**CONTRACT NO: FACD08 RESTROOMS AT PREBLE TRUCK PARKING
PROJECT: DOT-250005**

ADDENDUM NUMBER TWO (2)

FACD08 Restrooms at Preble Truck Parking
Ohio Department of Transportation (ODOT)
I-70 WB @ MM 01, New Paris, Ohio 45347
Preble County

SHEET
A.101

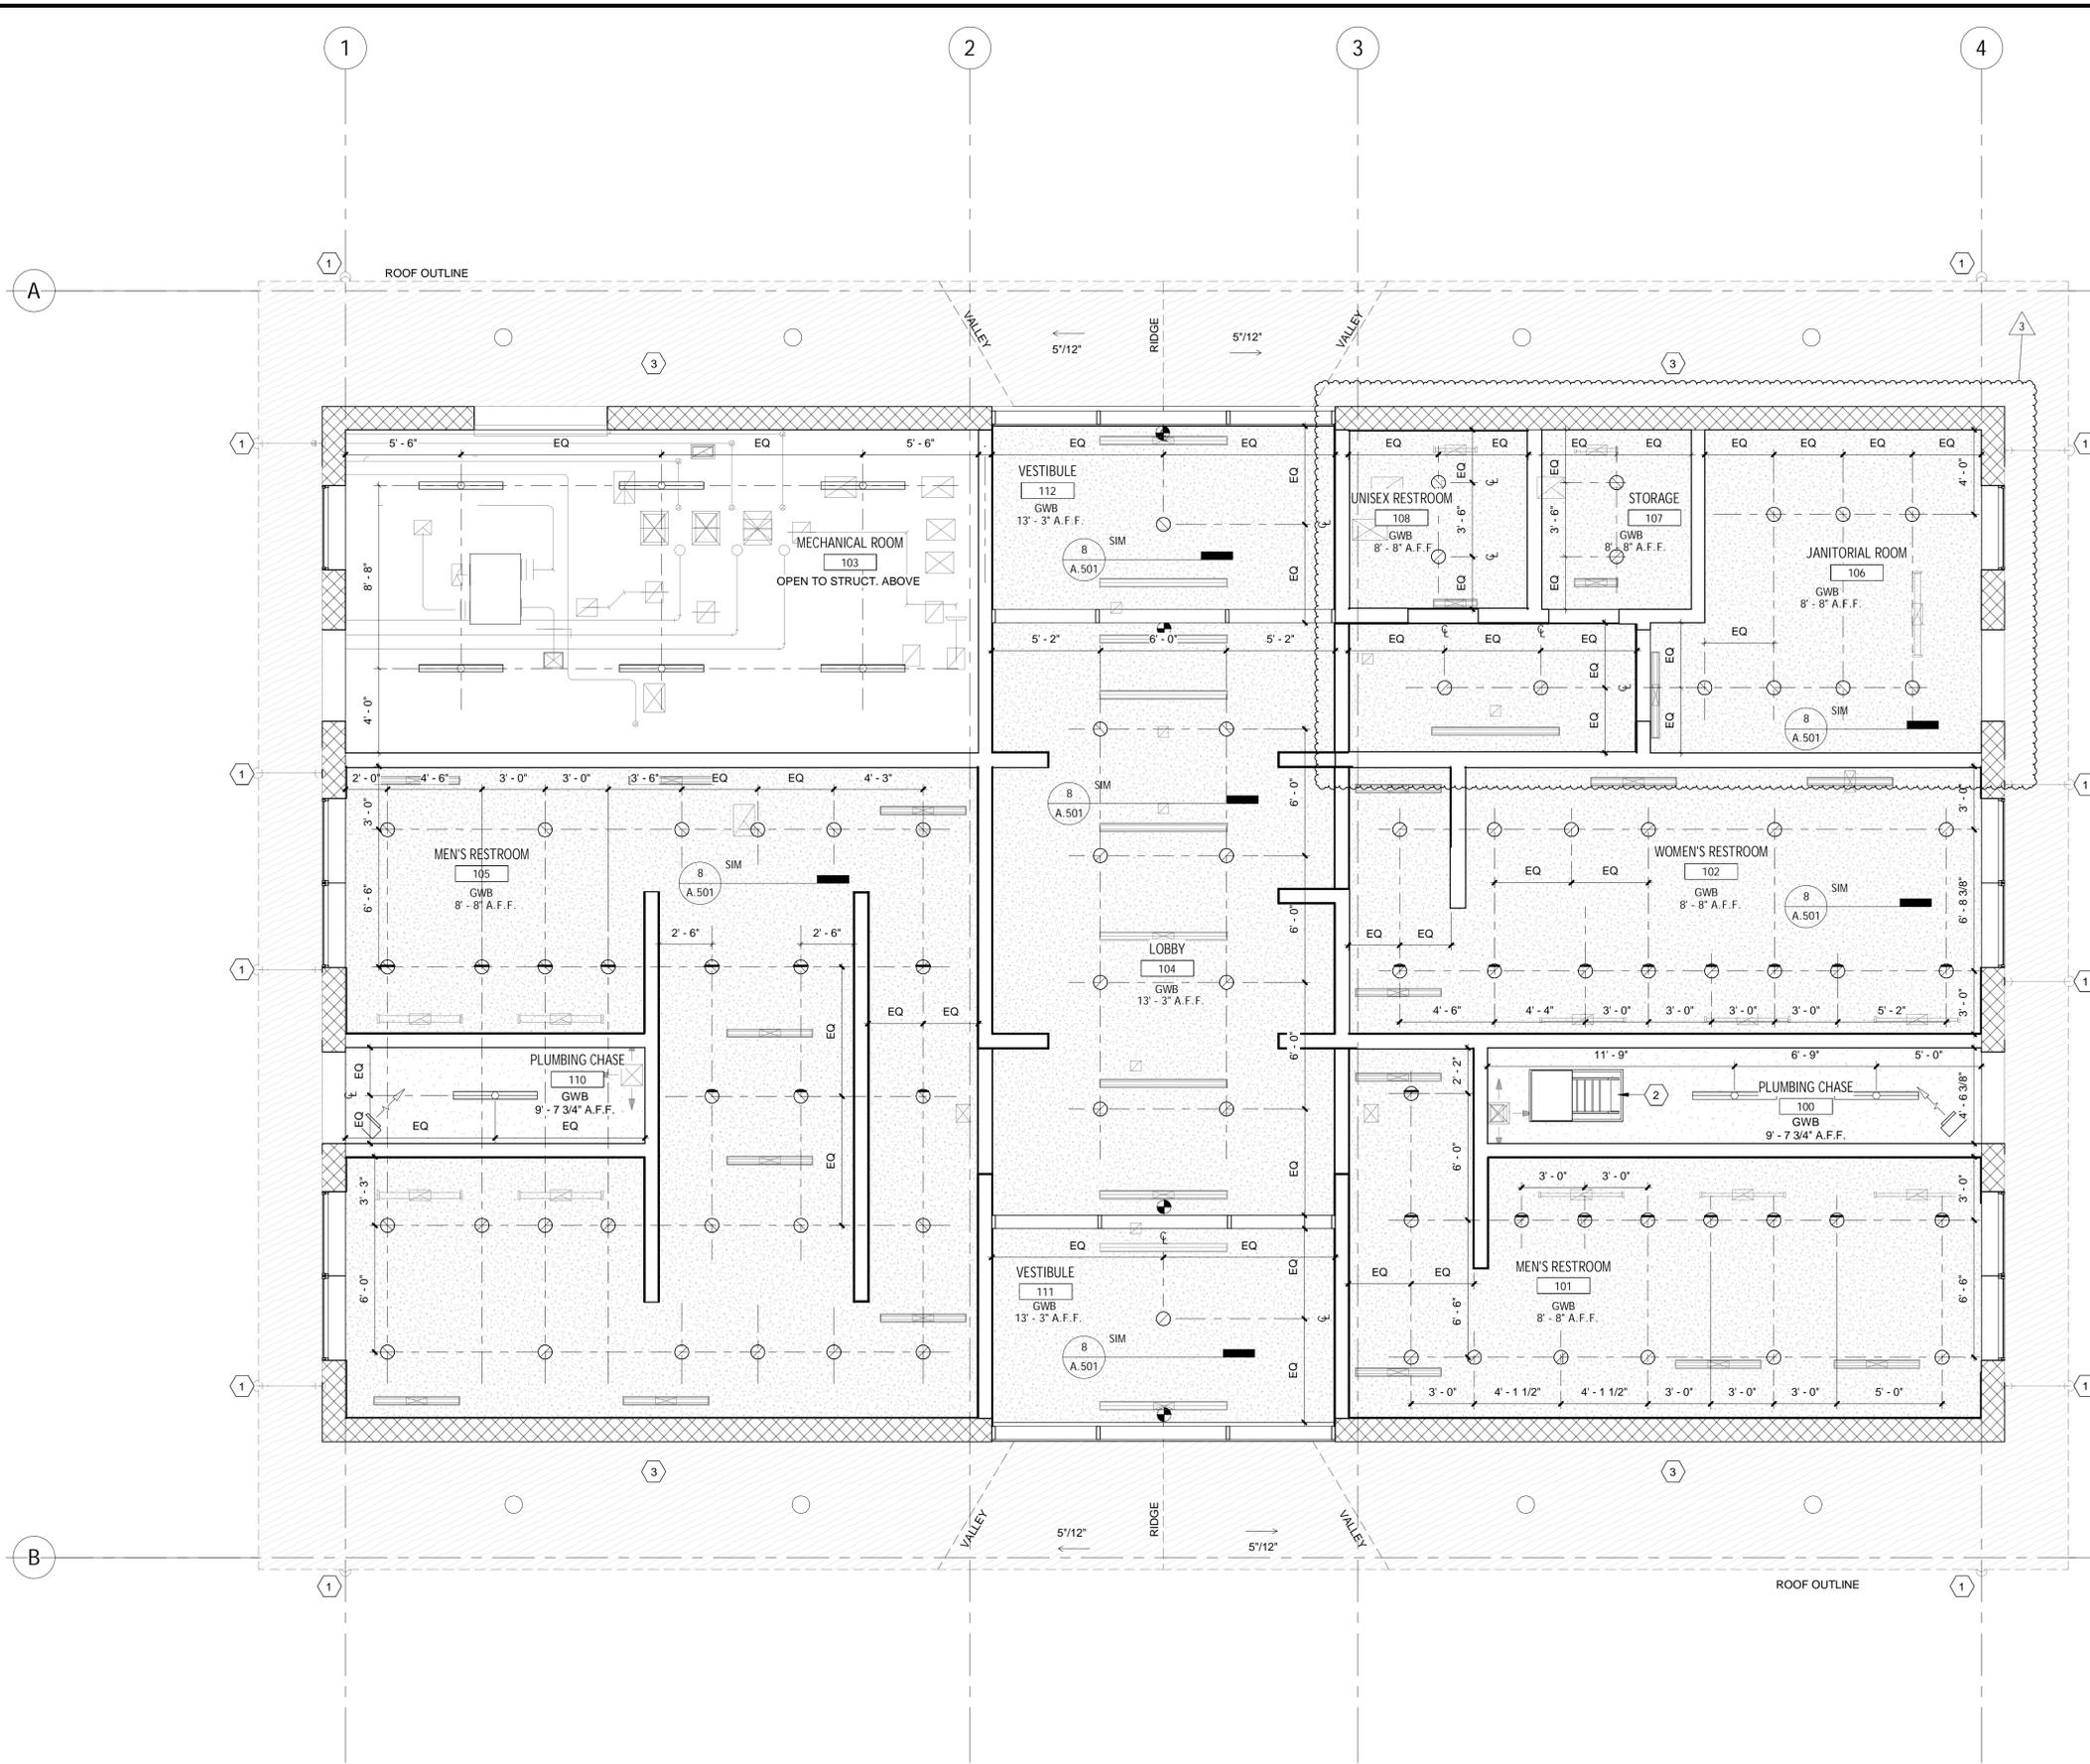
D-01. G.002, A.101, A.102, A.400, A.600 have been revised to allow space for adult changing station in Unisex Restroom 108

SHEET
A.301

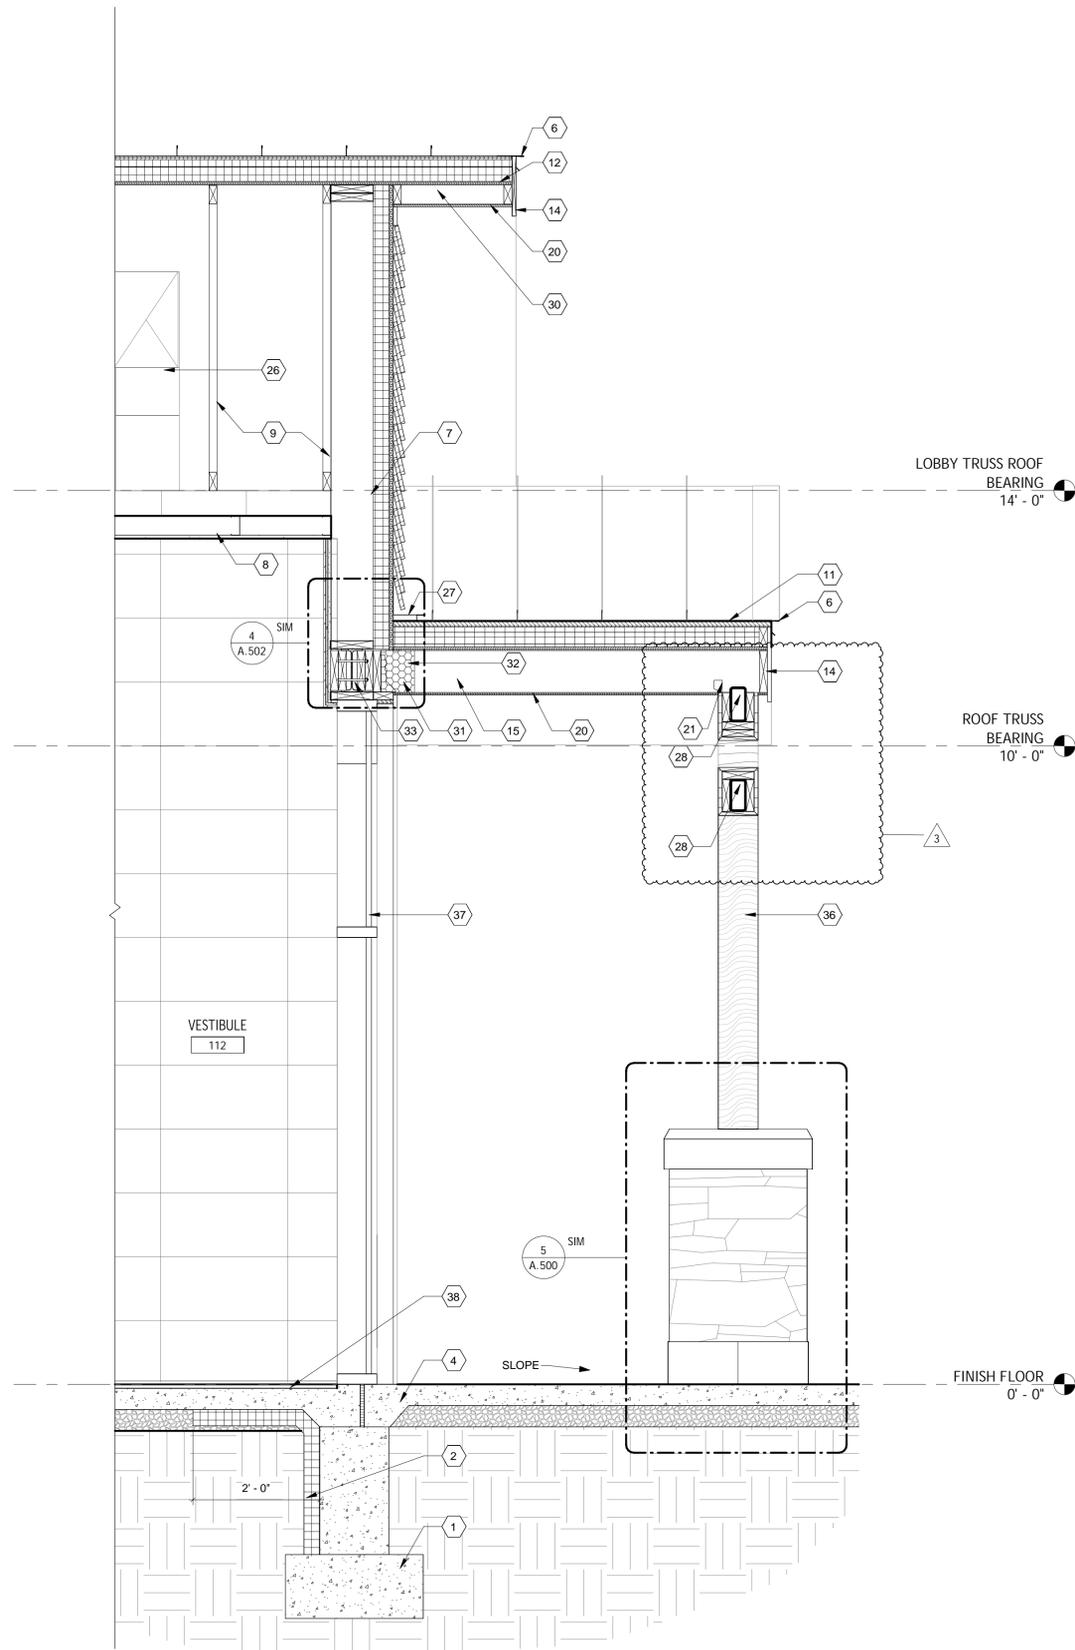
D-04. A.301 has been revised to show steel sizing

SHEET
A.302

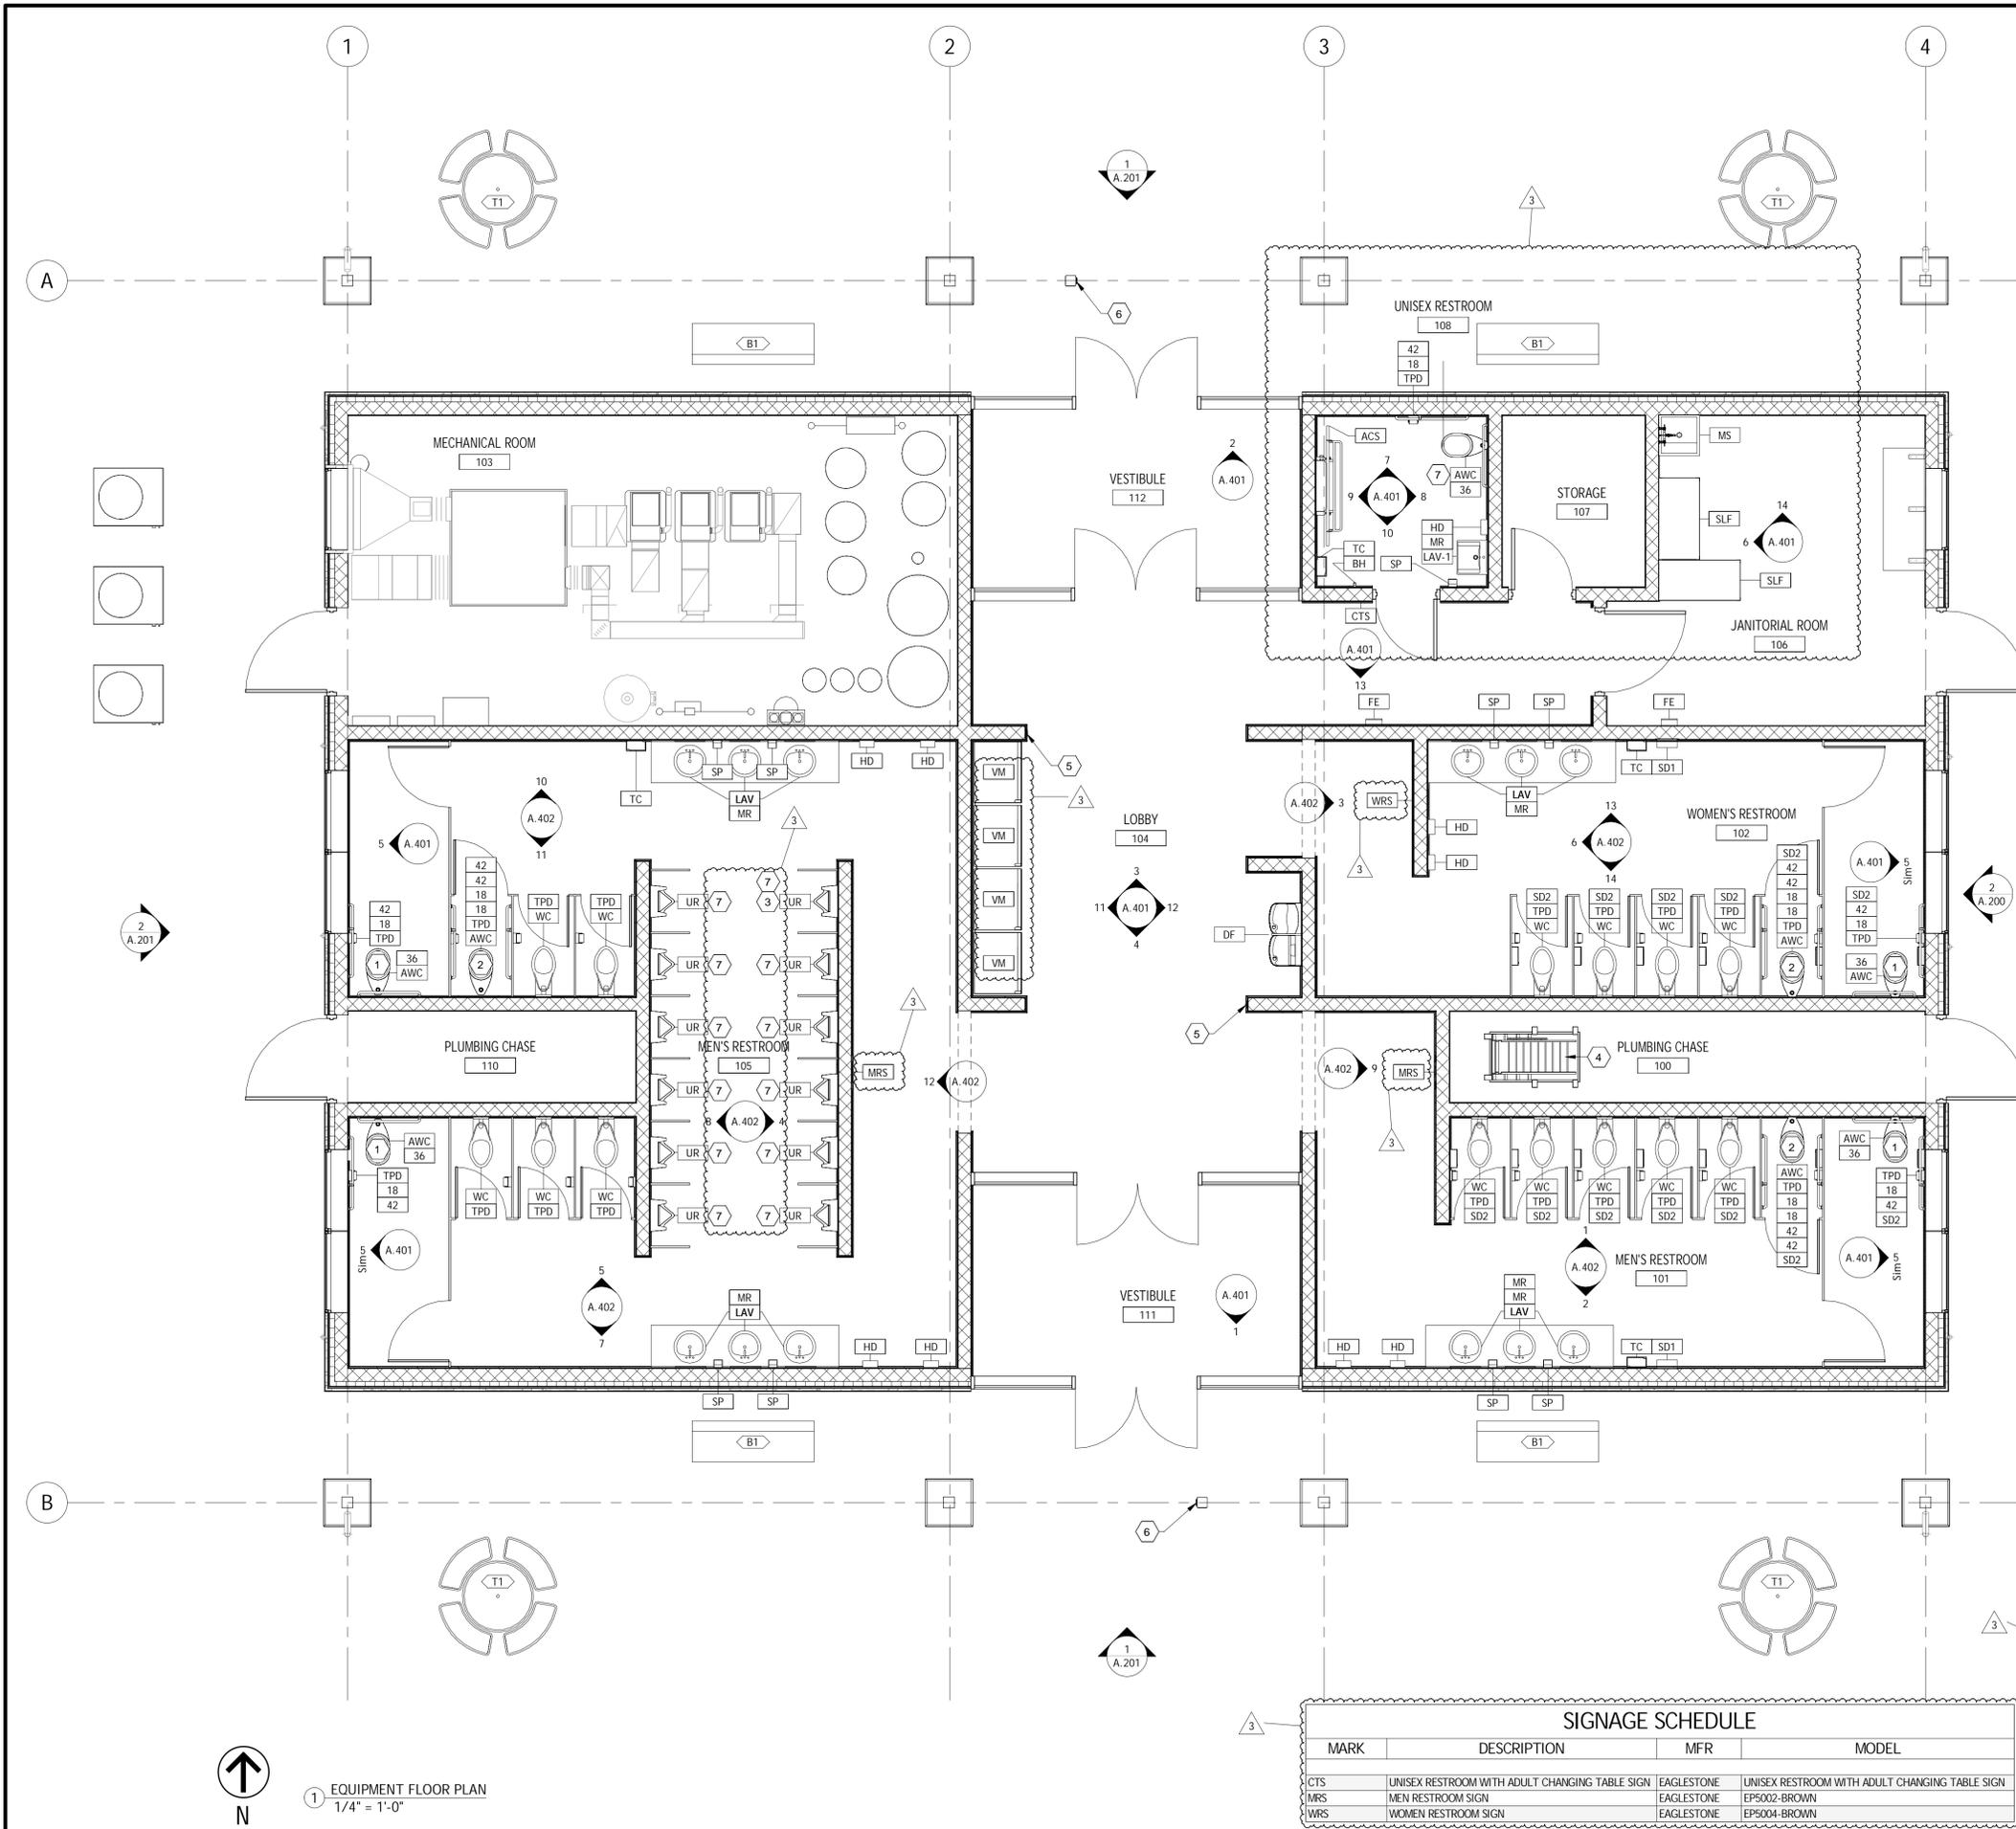
RFI-16: A302 shows two wood-wrapped steel beams per coded note 28. Please provide structural drawings/details for these beams.

Response: See revised structural drawings.

4 BOLLARD DETAIL
3/4" = 1'-0"

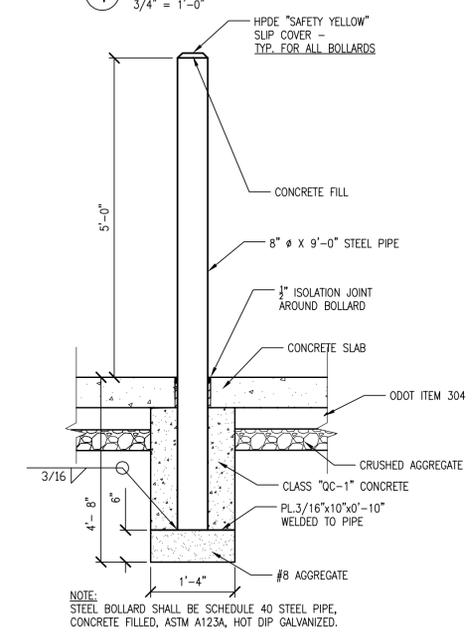
RFI-13: C102 shows 6" bollards, but C116 shows 8" bollards. Which is the correct size?

Response: Size is 8" for bollards
